Proposed Quarry Hill Road Te Aroha – Transportation Assessment.

Harrison Transportation has prepared a Transportation Assessment Report for a proposed quarry at 153 Hill Road Te Aroha. That report is dated September 2017. Council has, in their letter of 31 October 2017, requested further information. This report provides the requested information on traffic matters.

Figure 1: Expected Peak Hour Turning Movements (veh/h).

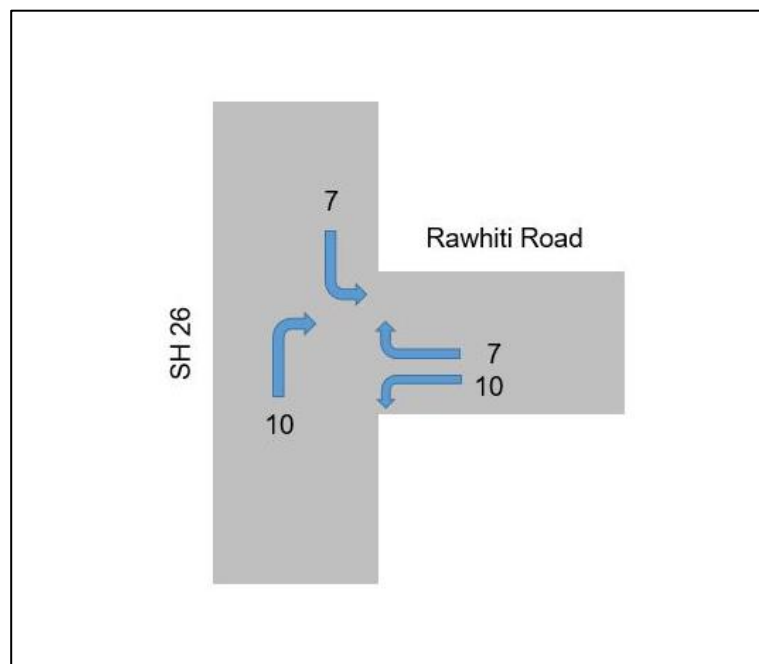
Figure 1 shows that the predominant turning movements are expected to be the right turn in and the left turn out of Rawhiti Road.

Figure 2: Warrant for Right Turn Bay.

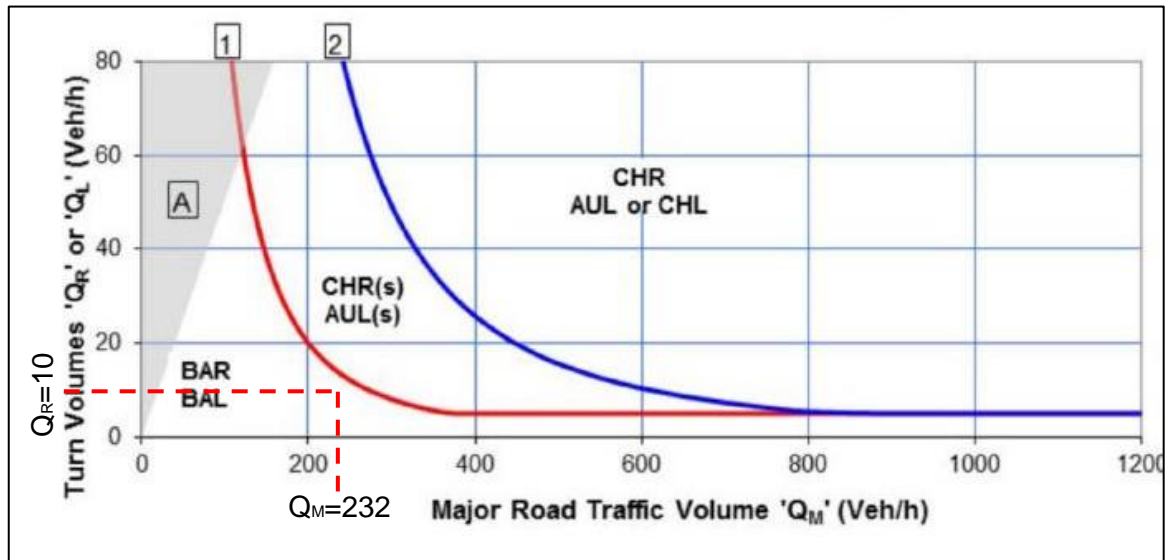
The intersection does not presently have a right turn bay provided. Recommendations for the provision of right turn bays at intersections are given in the Austroads *“Guide to Road Design Part 6: Intersections, Interchanges and Crossings”*. The assessment of the requirements for a right turn bay during the peak period is shown on the following figure.

Figure 2 shows that the provision of a right turn bay is not warranted.

CARO LTD
Hill Road, Te Aroha
Proposed Passing Bays

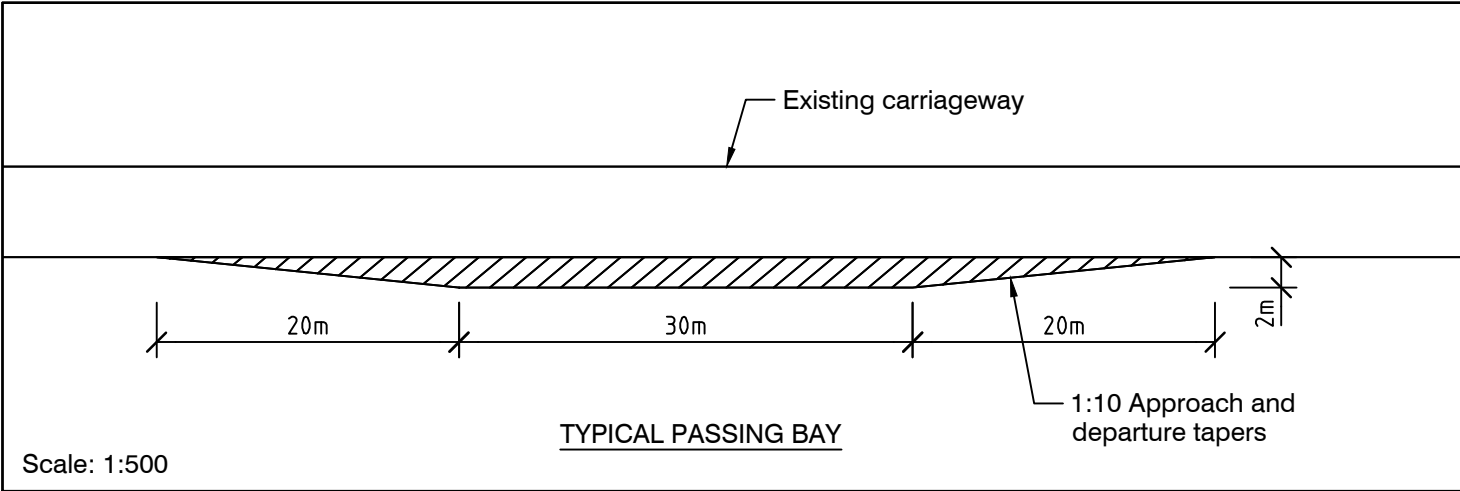
Council has requested that the entry and exit tapers to the passing bays be shown and that the passing bays at RP920 and RP1025 be connected. A review of the proposed passing bays has been carried out, with two additional passing bays now proposed, as well as incorporating Council's comments. The revised passing bays are as follows:

- RP0.0, right hand side, on the approach to the intersection with Rawhiti Road. This will allow a vehicle to enter Hill Road while a vehicle is waiting to turn out.
- RP225, right hand side, as previously proposed.
- RP380, right hand side. This was previously at RP430 but has been moved to provide better visibility into the dip.

- RP650, right hand side, as previously proposed.
- RP920 and RP1025, right hand side, combined into a single passing bay.
- RP1310, right hand side, an additional passing bay.
- An additional passing bay immediately within the site.

The above locations are indicative. It is recommended that the final locations be inspected by Council's roading engineers prior to construction, so that any minor adjustments to the location that may be required can be carried out.
